PLANNING COMMISSION

July 26, 2016

SUBJECT: PUBLIC HEARING - SPECIAL USE REQUEST AND PRELIMINARY SITE PLAN REVIEW (File Number JPLN2016-0020) – Proposed Rite Aid Pharmacy Drive Through Addition, Southeast Corner of South Boulevard and Crooks (1981 W South Boulevard), Section 04, Currently Zoned NN “U” (Neighborhood Node “U”) District

SUBJECT: PUBLIC HEARING - SPECIAL USE REQUEST AND PRELIMINARY SITE PLAN REVIEW (File Number SU JPLN2016-0017) – Proposed 1-800 Self Storage Facility, East side of Coolidge, South of Maple (1330 Coolidge), Section 32, Currently Zoned MR (Maple Road) District

NORTH ELEVATION- PHASE I & II

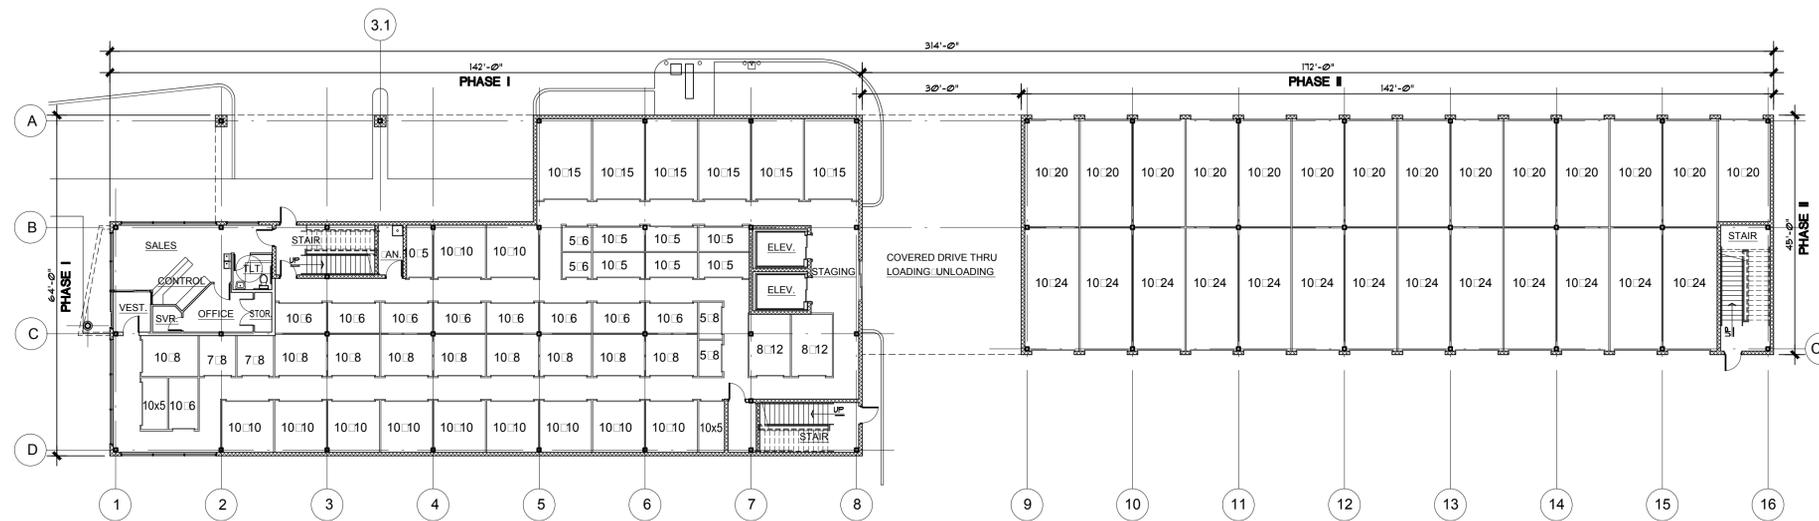
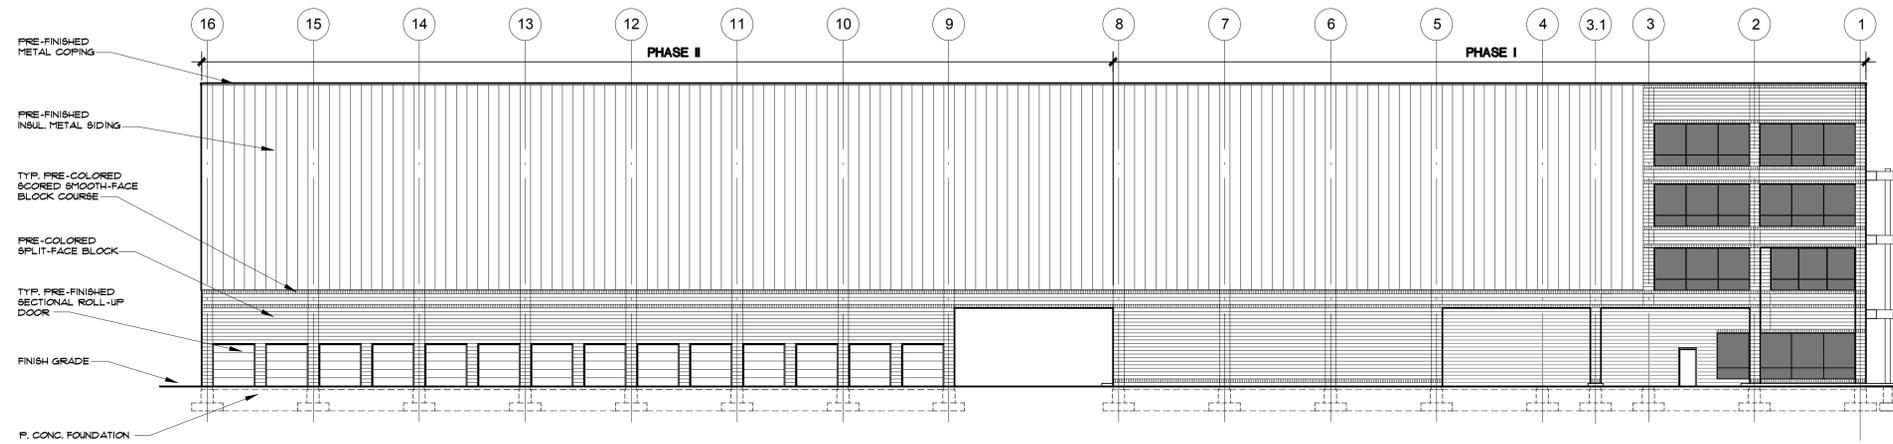
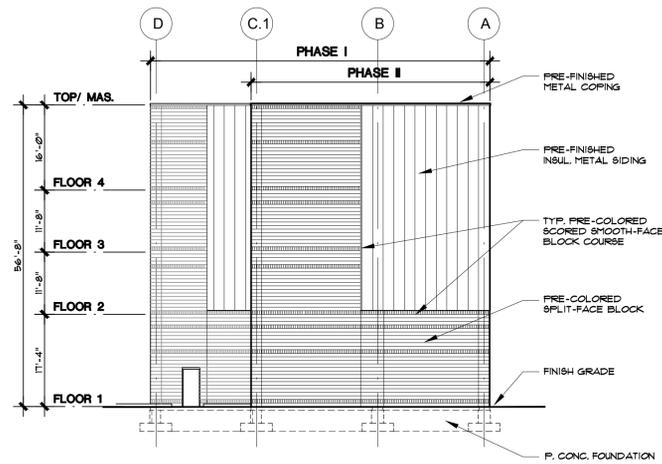
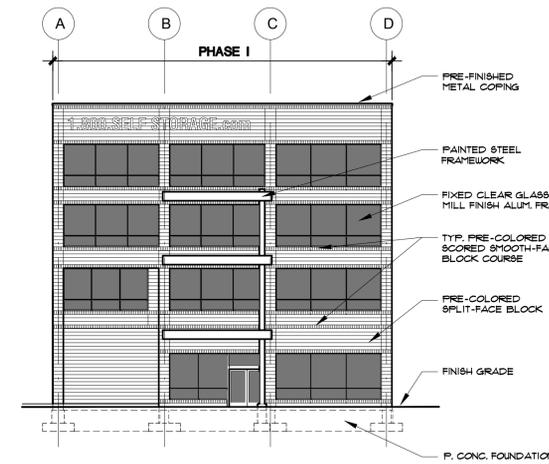
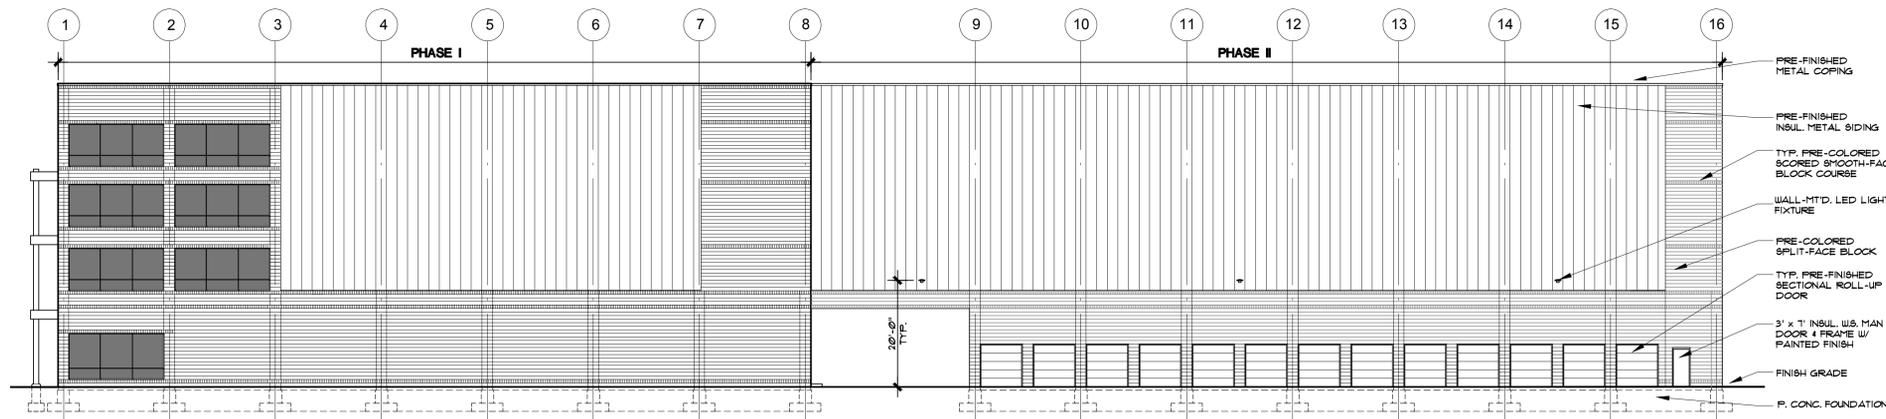
The north, south and east elevations have minimal architectural details. The Planning Commission should consider if additional architectural treatments would be appropriate for the north and south elevations.

Items to be Addressed: The Planning Commission should consider if additional architectural treatments would be appropriate for the north and south elevations.
